SYDNEY METRO VICTORIA CROSS OSD CONCEPT SSD DA MODIFICATION (SSD- 8874-MOD-1) & DETAILED SSD DA (SSD-10294)

RESPONSE TO SUBMISSIONS

Figure 1 – Anticipated subdivision staging

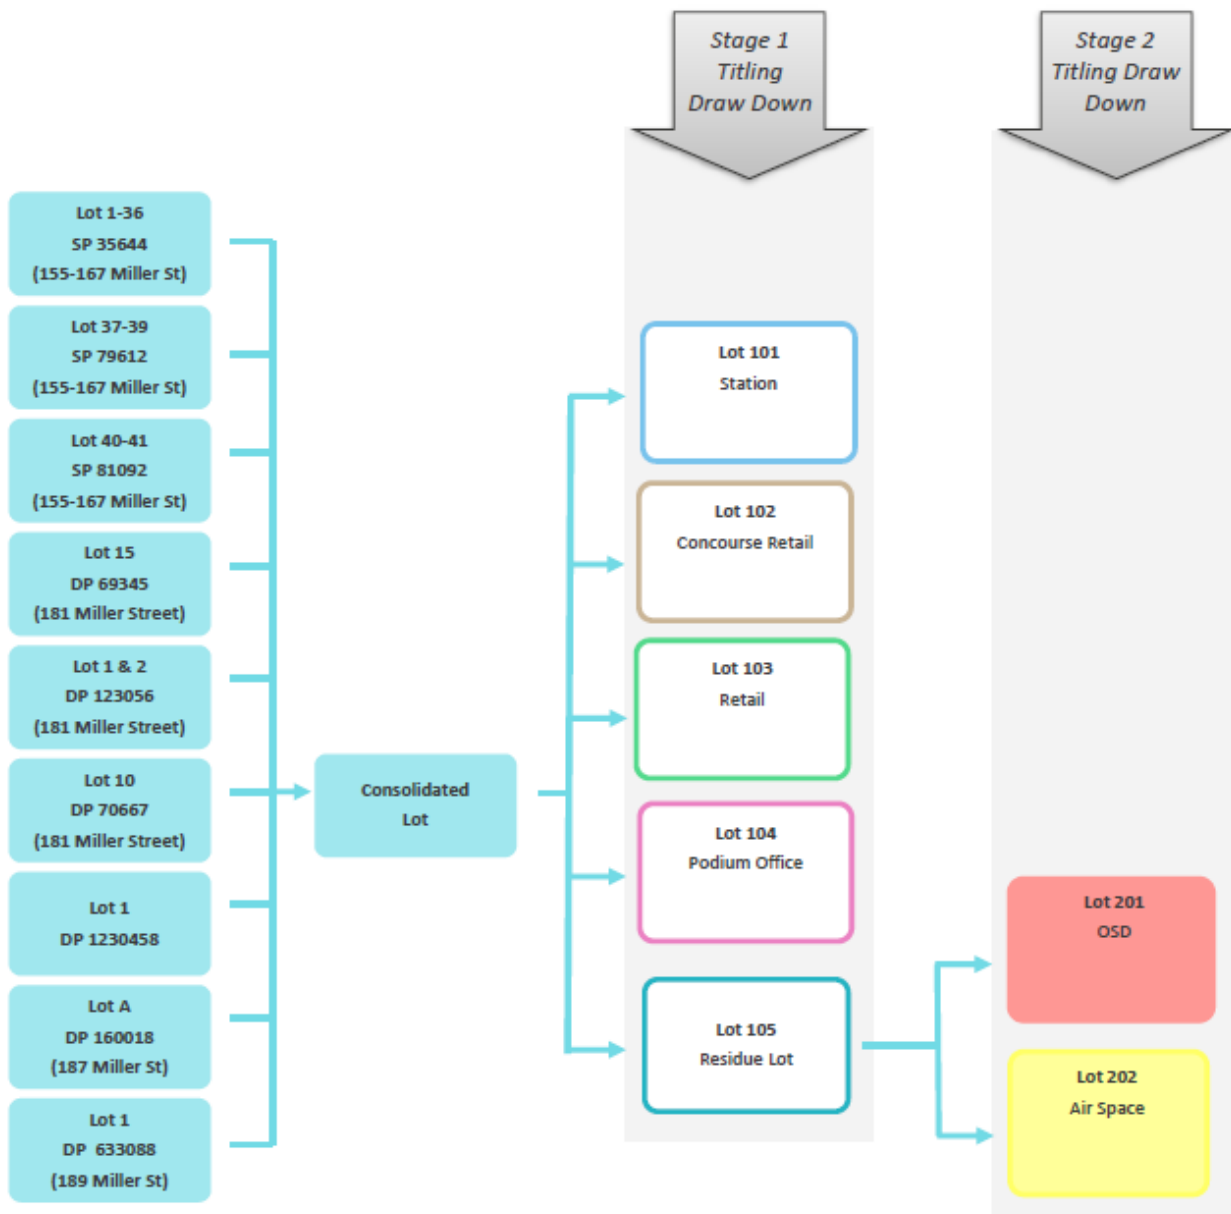
The anticipated staging is demonstrated by **Figure 1** below (updated figure from EIS). The anticipated Stage 1 titling relates to everything below the transfer level that aren't associated with the Tower. This includes, allotments for the metro station concourse retail, podium retail, secondary / podium commercial office floor space, and residue areas.

Given the design for areas below the transfer level are continually evolving, flexibility is required for effected lot boundaries within the CSSI 'metro box'. The subdivision plans include provisions to accommodate for potential changes to lot boundaries. The anticipated Stage 2 titling relates to everything associated with the commercial tower and the air space around the tower.
